I have reviewed the revised plans for planning application 2021/6234/P and have meet with the applicant's architect too. Regrettably, I feel I must submit a further objection on the following grounds:

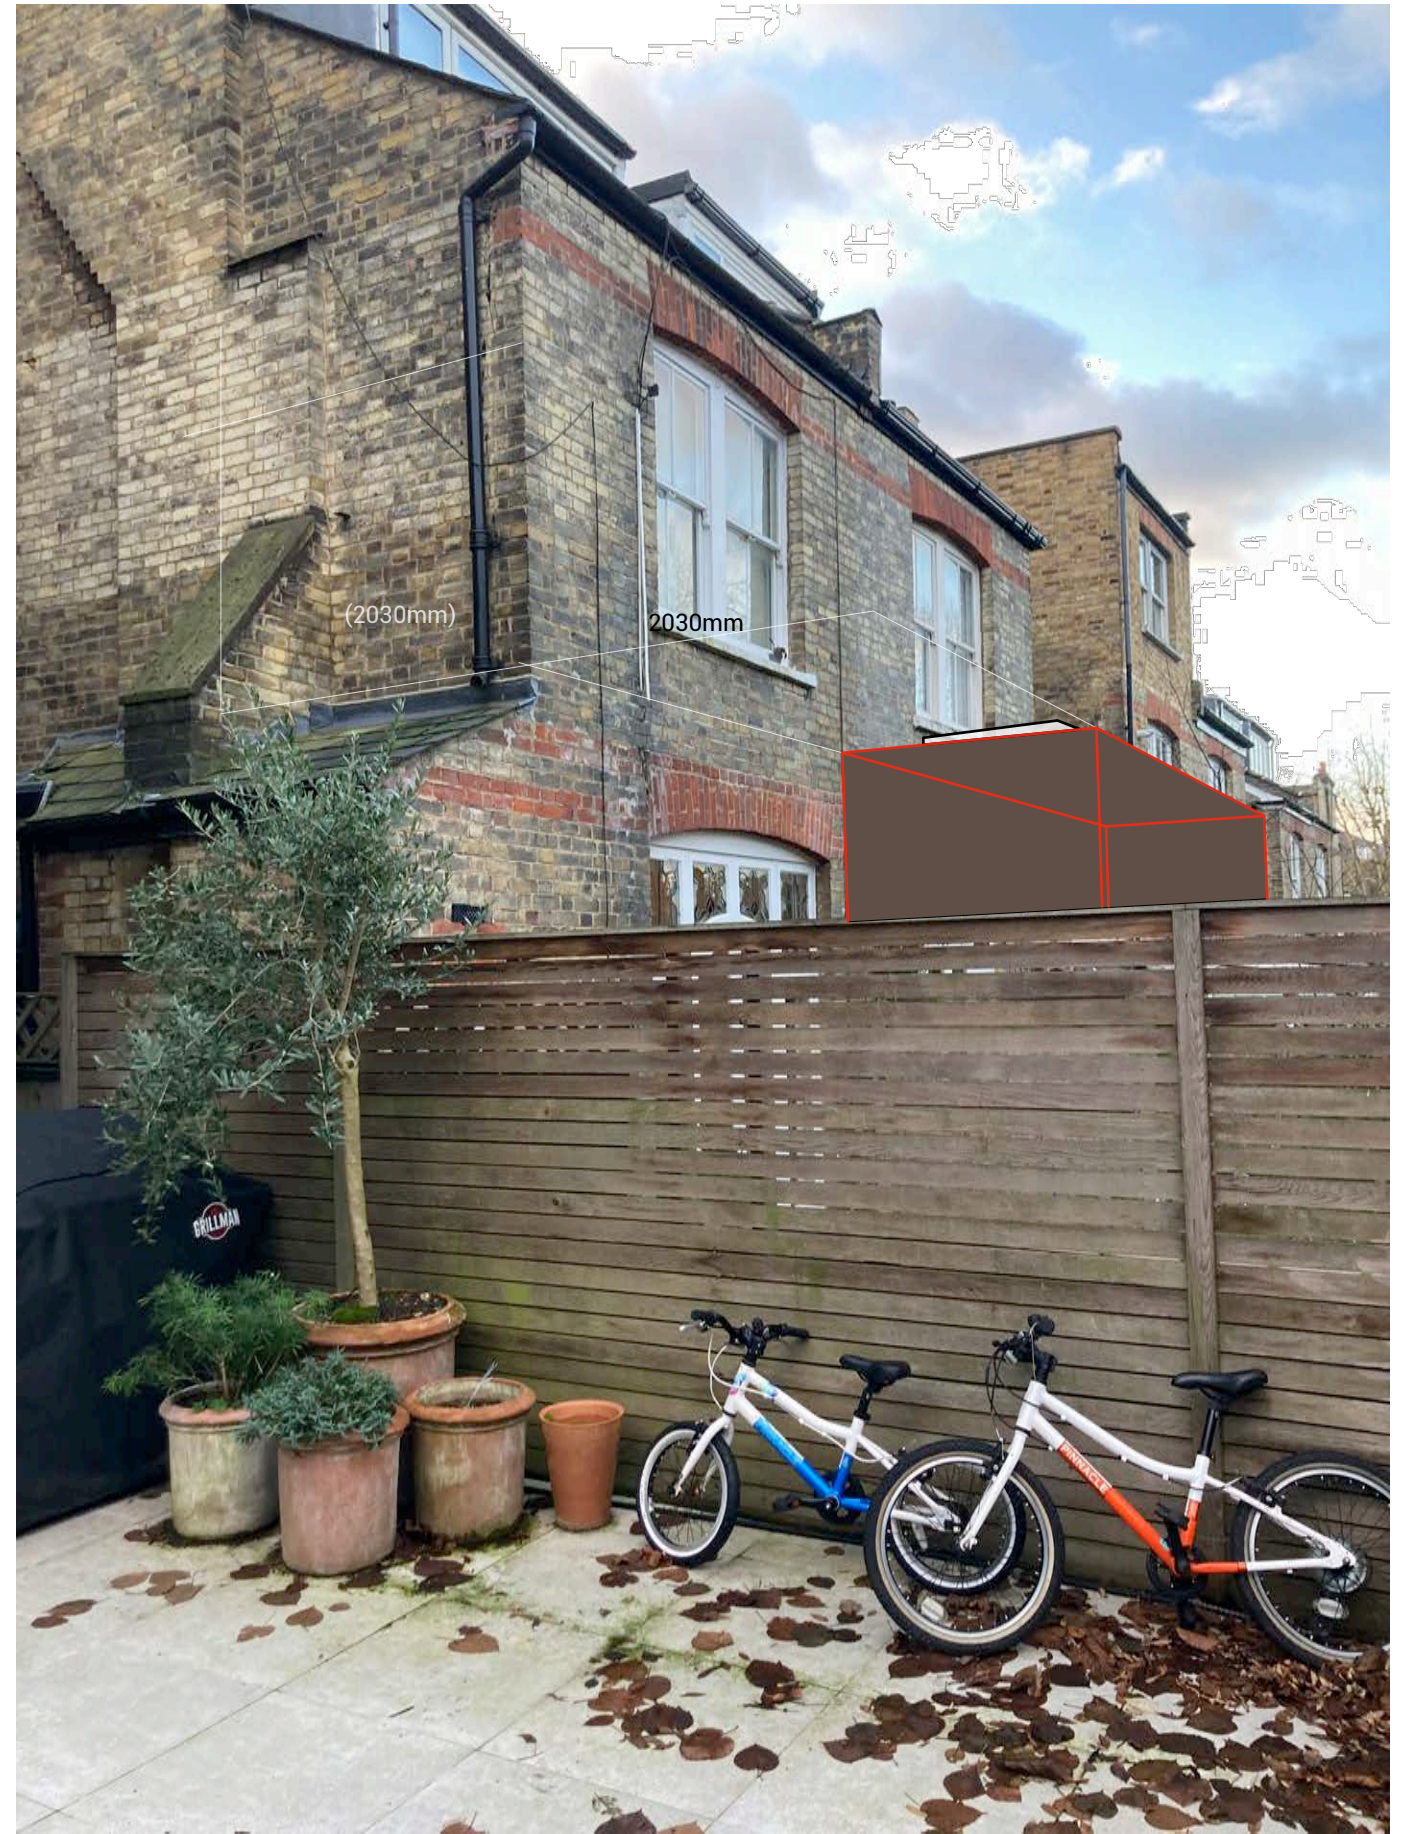
To aid your appraisal of the application and demonstrate the real visual impact of the extension, please see Appendix 1, images showing the massing of the proposed extension as viewed from my property from various angles and in the context of adjoining properties.

The proposed extension is over-bearing, incongruous with the surrounding properties and ruins the uniform design and features of the rear elevation of the terrace. For me and occupiers of any other adjoining properties, open sky and greenery are replaced by a tall brick wall, that cannot be acceptable.

Although all neighbouring properties will suffer from the light pollution, most notable must be the impact on the 1<sup>st</sup> Floor of 14 Glenmore Road, this part of the building does not form part of the application property. As demonstrated by the images in Appendix 1, the rooflight is extremely close to the adjoining owner's window, the light pollution will have a negative impact of the well-being of the 1<sup>st</sup> floor occupier. It cannot be acceptable in planning terms to permit such an issue to be created, even if the current occupiers are both willing to accept the issue.
